Access Compliance Report Public Rights-of-Way (Curb Ramps)

Main Street: TERRASTAR_LN Cross Street: BLACK_CHERRY_ST Location: NW

ADA ID: RPAT211101094055 Ramp Type: Type 4 - Parallel Initial Pass/Fail: Fail Overall Compliance: No Severity Score: 16

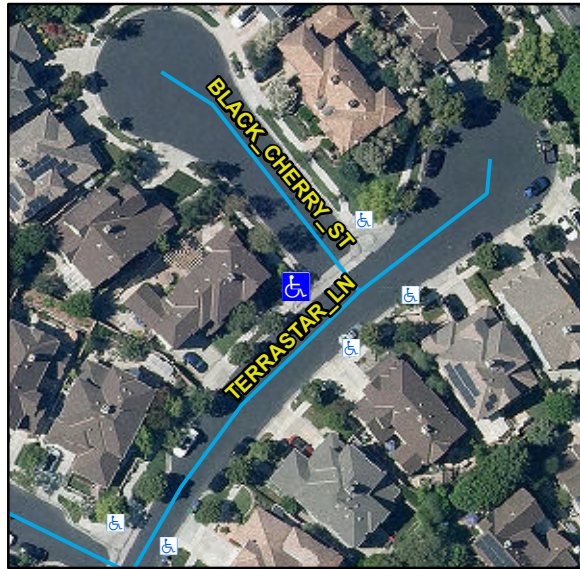
Compliance	Description	Data	Compliance	Description	Data
N/A	Ramp Length LT (in)	100	N/A	Ramp Length RT (in)	105
Yes	Ramp Width LT (in)	55	Yes	Ramp Width RT (in)	54
Yes	Ramp Run Slope LT (%)	3.9	No	Ramp Run Slope RT (%)	11.5
No	Ramp Cross Slope LT (%)	3.6	No	Ramp Cross Slope RT (%)	2.7
N/A	Landing Present	N/A	N/A	DWS Provided	N/A
N/A	Landing Length (in)	N/A	N/A	DWS Contrast	N/A
N/A	Landing Width (in)	N/A	N/A	DWS Length (in)	N/A
N/A	Landing Run Slope (%)	N/A	N/A	DWS Full Width	N/A
N/A	Landing Cross Slope (%)	N/A		DWS Offset Type	N/A
N/A	Landing Movement Obstructed?	N/A	N/A	DWS Offset Left (in)	N/A
	Landing Movement Type	N/A	N/A	DWS Offset Right (in)	N/A
N/A	Landing Shared	N/A			
N/A	Clear Space	Yes			
N/A	Clear Space To Crosswalk (in)	N/A			
N/A	Marked Crosswalk 1	No	N/A	Marked Crosswalk 2	No
	Crossing 1 Direction	S		Crossing 2 Direction	E
	Marked Crosswalk 1 Width (in)	N/A		Marked Crosswalk 2 Width (in)	N/A

N/A	Ramp Inside Crosswalk 1	N/A	N/A	Ramp Inside Crosswalk 2	N/A
	Crossing 1 Slope (%)	3		Crossing 2 Slope (%)	3.8
	Crossing 1 Cross Slope (%)	2.5		Crossing 2 Cross Slope (%)	2
N/A	Gutter Ponding	N/A	N/A	Curb Slope	9.4
Yes	Gutter Lip Height (in)	0		Road Run Slope (%)	2.2
N/A	Gutter Run Slope (%)	N/A		Road Cross Slope (%)	0.1
N/A	Gutter Cross Slope (%)	N/A	No	Perpendicular Joint Present	No
Yes	Overall Surface Condition	Acceptable			
	Cross Gutter Present?	Yes		Spandrel Present?	Yes
	Replace Cross Gutter?	No		Replace Spandrel?	No

Remove & Replace Curb Ramp With Two New Directional Ramps or Equivalent.

R204.3, R304.5.3, R304.3.2, STD 1115
